## Pre-Decisional Enforcement Conference Inspection Report 07201014/2022-201

# Agenda

# MPC-68M Versions

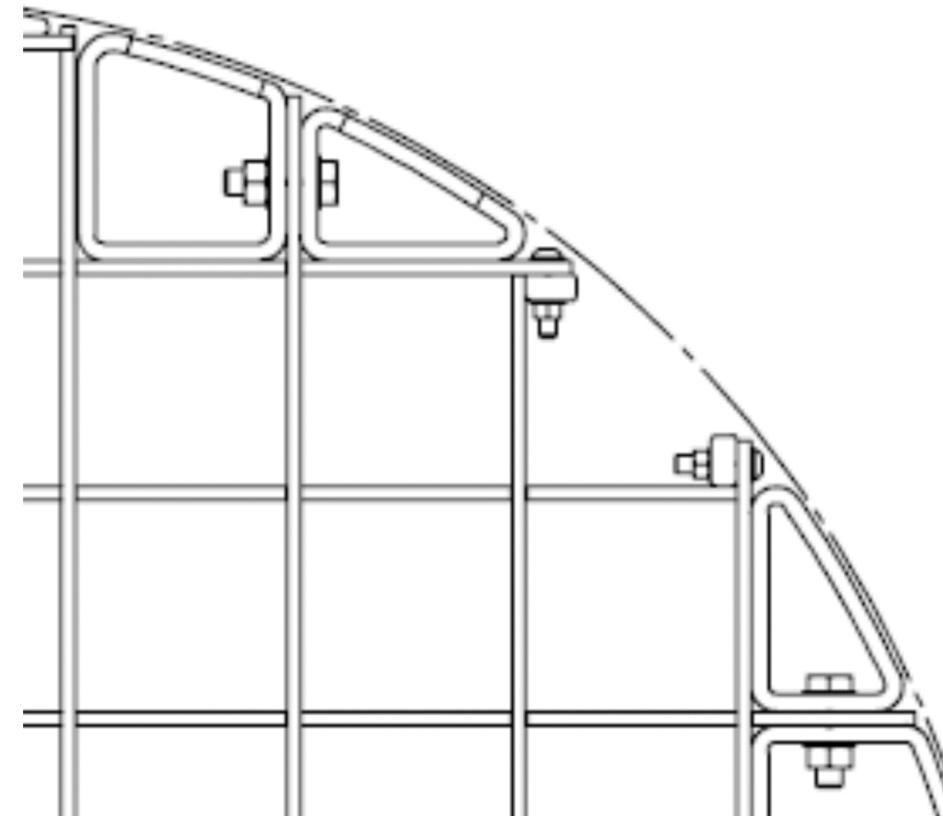
- “1) As described in FSAR revision 22, section 3.III.4.4.3.1(iii), Holtec tied the nodes of the shim to the basket panel at the bolt hole locations to replicate bolted connections at the bolt hole locations the resultant of which changed the way the connections are modeled between the fuel basket and the shims in the FEA model and did not explicitly model the new bolts. Holtec implemented the modification and revised FSAR revision 21, section 3.III.4.4.3.1 (original design) in which the **corner welds between the standard basket and shims** were modeled by bonding the corner elements and assigning them the elastic material properties of the weld, effectively modeling the welds in the FEA. **The team considered this an element change because it was a change to the overall FEA model associated with the tip-over analysis”**

## ■ Response to Item 1

- ✓ The corner welds described in FSAR Revision 21 are between intersecting Metamic panels within the actual basket structure, there are no welds between “the standard basket and shims”

- ✓ Holtec uses NEI 12-04 as 72.48 program basis, as endorsed by NRC in Reg Guide 3.72
- ✓ NEI 12-04 specifically discusses dimensional changes as input changes which are different than methodology which is “calculational framework” which tend to involve a mathematical expression

- ✓ Holtec modeled the accurate dimensional and physical changes that occurred with the CBS design change and **did not** change the calculational framework of the analysis

- ✓ Previously established understanding of NRC guidance was that a change to the FEA model to accord with geometric changes was not automatically considered a change to the methodology

- Definition of “method of evaluation” in NEI-12-04 is based on “calculational framework”
  - Examples of mathematical models that would be a change in methodology are methods of heat transfer and material performance – not geometrical changes

# MPC-68M Versions

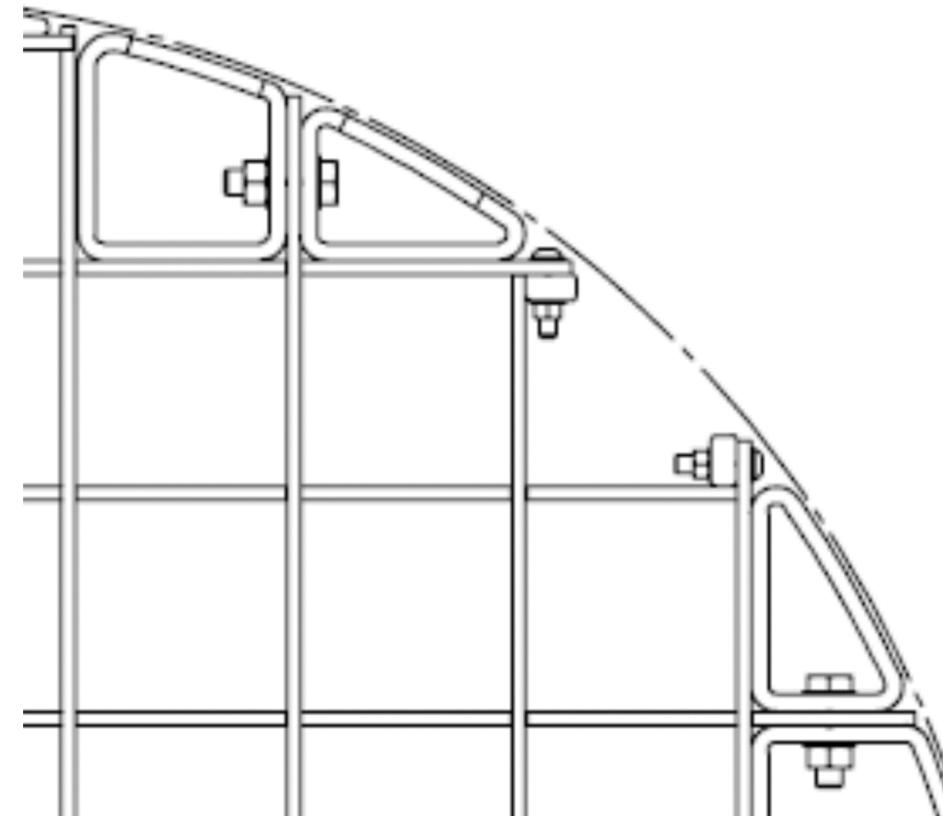
- “2) As described in FSAR revision 22 section 3.III.4.4.3.1(iii), the impact load between the fuel basket and the shims is directly transferred between shims and the horizontal basket panel adjacent to them without inducing shear in the bolts. Additionally, for the modified design, calculation HI-201787-Rev 39, supplement 79, evaluates the bolts for solid shims using an applied 60-g bounding lateral deceleration load from the weight of the basket and fuel assembly, the resultant of which changed the way the strength evaluation was performed for the connections between the fuel basket and the shims. Previously, for the standard basket design, Holtec evaluated **basket welds** using outputs from the FEA to determine the applied moment and shear load as documented in attachment 2 to supplement 65 of Holtec calculation HI-201787-Rev 38. **The team considered this a new or different MOE because Holtec changed the calculational framework on how to evaluate the shims.**”

## ■ Response to Item 2

- ✓ As in item 1, this is a direct result of the change in geometry of the basket/shim configuration
  - The corner welds described in FSAR Revision 21 are between intersecting Metamic panels within the actual basket structure

- There are no welds between “the standard basket and shims”
- ✓ For the standard (FSW-based) basket design, there is no physical connection between the fuel basket and the shims

- ✓ Evaluation performed for friction stir welds used direct outputs from the ANSYS simulation
  - Friction Stir Welds were an integral part of the standard basket design - not the shims

- ✓ Bolts are a separate physical component
  - A separate analysis was performed as necessary to demonstrate their suitability for the solid shims
- ✓ Not considered a change in methodology - if welds still existed they would have been analyzed using the previously established method

- ✓ Since the CBS basket introduced a different component it was analyzed using a bounding load consistent with the FEA model framework

# MPC-32M Variants

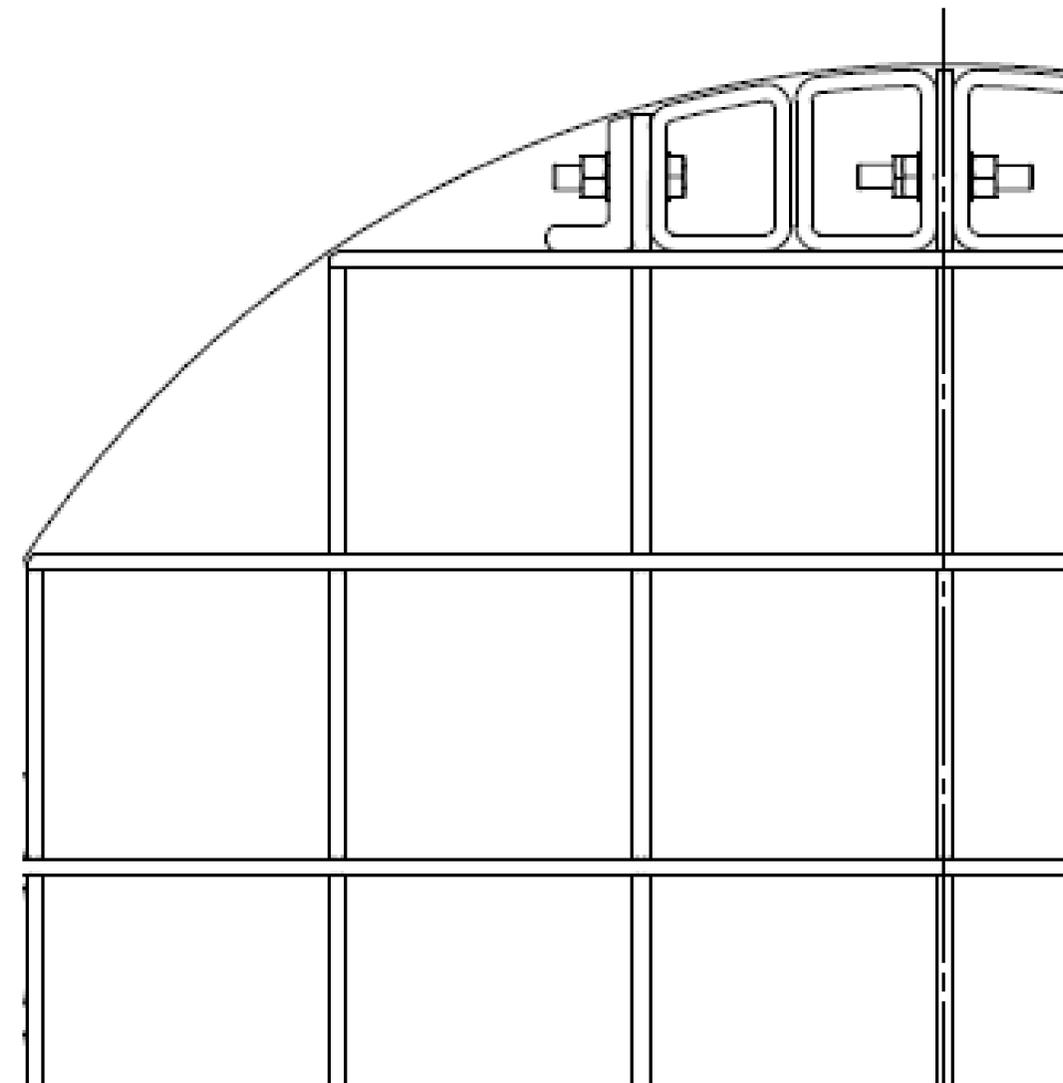
- “6) As described in appendix E.1 of HI-2188448-R3, the impact load between the fuel basket and the shims is directly transferred between the shims and the horizontal basket panel adjacent to them without inducing shear in the bolts. For the standard basket design, Holtec evaluated the welds using an applied 100-g bounding fuel deceleration load in appendix C of HI-218848-R3 (as referenced in HI-STORM FSAR revision 23, section 3.II.4.4.2(ii)). The team considered this a different MOE because **Holtec changed the way the strength evaluation was performed for the connections between the fuel basket and the shims by using a different assumption, which was inconsistent with the previous licensing basis assumptions.** (similar to AV A.2)

- “7) As described in appendix N of HI-2094353, “Analysis of Non-Mechanistic Tip-Over Event of Loaded HI-STORM FW Storage Cask,” Holtec used a nodal constraint to tie the shims to the basket panels at the bolt hole locations, the resultant of which changed the way that the connections are modeled between the fuel basket and the shims in the FEA model. In addition, Holtec did not model the bolts for the CBS design. **Previously, Holtec modeled the corner welds between the standard basket and shims** by bonding the corner elements and assigning them the elastic material properties of the weld, effectively modeling the welds in the FEA. The team considered this an element change because it was a change to the overall FEA model associated with the tip-over analysis. (similar to AV A.1)

## ■ Response to Item 6

- ✔ Similar to item 2, this is a direct result of the change in the basket/shim geometry
  - The corner welds described in the FSAR are between intersecting Metamic panels within the actual basket structure, there are no welds between “the standard basket and shims”

- ✔ For the standard basket design, there is no physical connection between the fuel basket and the shims, and therefore there is no FSAR method for evaluating basket-to-shim connections

- ✔ The evaluation performed for the Friction Stir Welds used direct outputs from the ANSYS simulation because those were an integral part of the standard basket (not the shims)

- ✔ This was not a change in methodology - if basket welds still existed they would have been analyzed the using previously established method
- ✔ Since the CBS basket variant introduced a different component (bolted shims), the bolts were analyzed using a bounding load consistent with the FEA model framework

## ■ Response to Item 7

- ✓ As stated in the response to Item 1, corner welds are between intersecting Metamic basket panels, not between “the standard basket and shims” as described in the inspection report

- ✓ Holtec uses NEI 12-04 as the guidance for executing the 72.48 program, as endorsed by NRC in Reg Guide 3.72
- ✓ NEI 12-04 specifically discusses dimensional changes as input changes which are different than methodology which is “computational framework” which tend to involve a mathematical expression

- ✓ Holtec modeled the accurate dimensional and physical changes that occurred with the CBS basket variant design change and did not change the computational framework of the analysis

- ✓ NRC guidance states that a change to the FEA model itself is not automatically considered a change to the methodology
  - Definition of “method of evaluation” in NEI-12-04 is based on “computational framework”

- Examples of mathematical models that would be a change in methodology are methods of heat transfer and material performance – not geometrical changes

# MPC-37 Variants

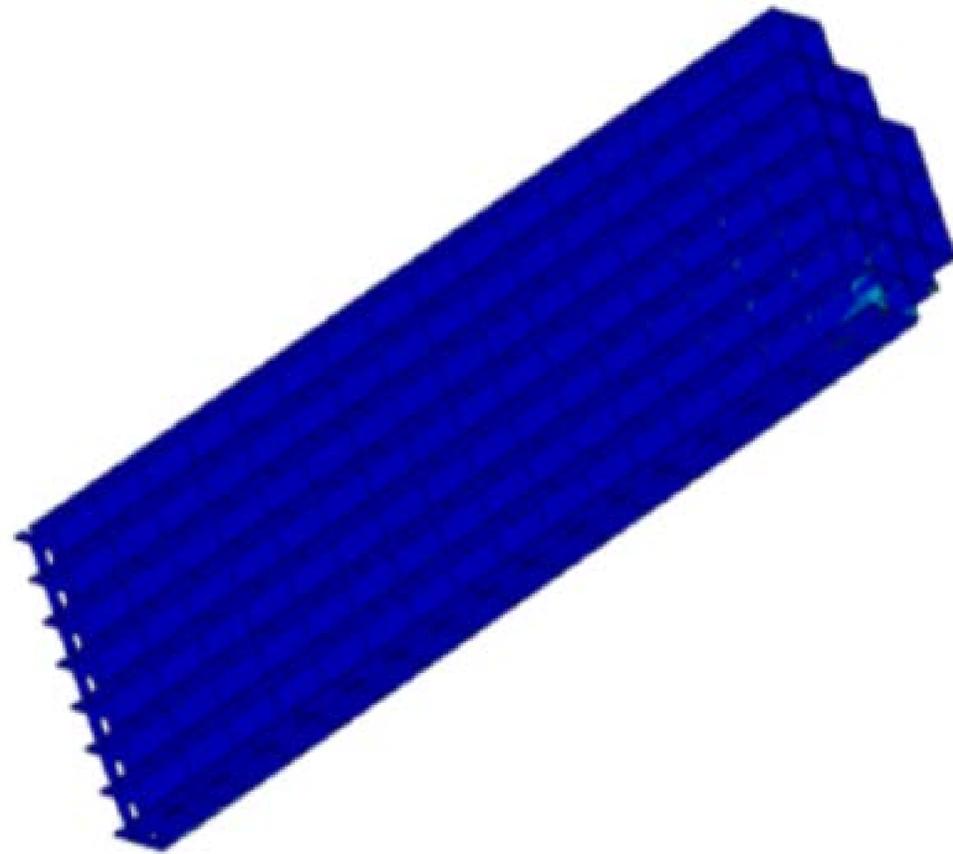
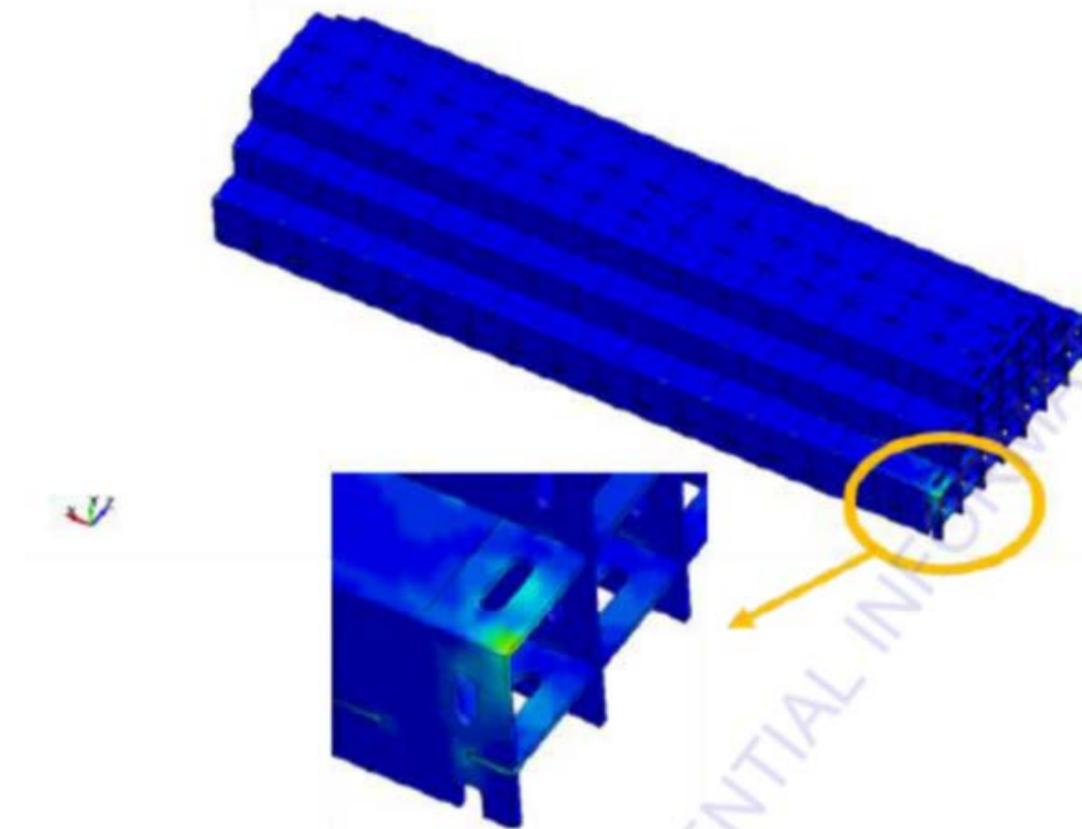
- “8) FSAR HI-2114830, revision 7, section 3.4.4.1.4b, states that lateral deflections from the tip-over analysis of the CBS basket comply with the deflection criterion in FSAR table 2.2.11. However, Holtec did not include lateral deflections of the CBS fuel basket design of the FSAR. Instead, Holtec documented that the maximum local plastic strains of the 89-CBS basket reached the rupture strain and depicted small plastic deformation in the active fuel region. For the 37-CBS basket, Holtec reported the maximum local plastic strains and provided figures of the maximum plastic strains, which showed small plastic deformation in the active fuel region of the MPC 37-CBS basket. Despite these results, Holtec incorrectly concluded that the fuel baskets did not experience any permanent deformation in the active fuel region in appendix N of HI-2094353. **The team considered this a different MOE because Holtec stated there was no plastic deformation. However, the changes being considered now show plastic deformation.**

## ■ Response to Item 8

- ✓ We submit that this is NOT a change in methodology – the results in the FSAR for the MPC-37-CBS basket are the same as those presented for the original design of the MPC-37
- ✓ The Holtec FSAR presented strain results in figures for the MPC-37
- ✓ For the MPC-37-CBS basket figures were also included in the FSAR to show strain results throughout the basket
- ✓ For both the original and CBS basket designs, the FSAR figures support the **same conclusion** that the basket meets the structural basket criteria
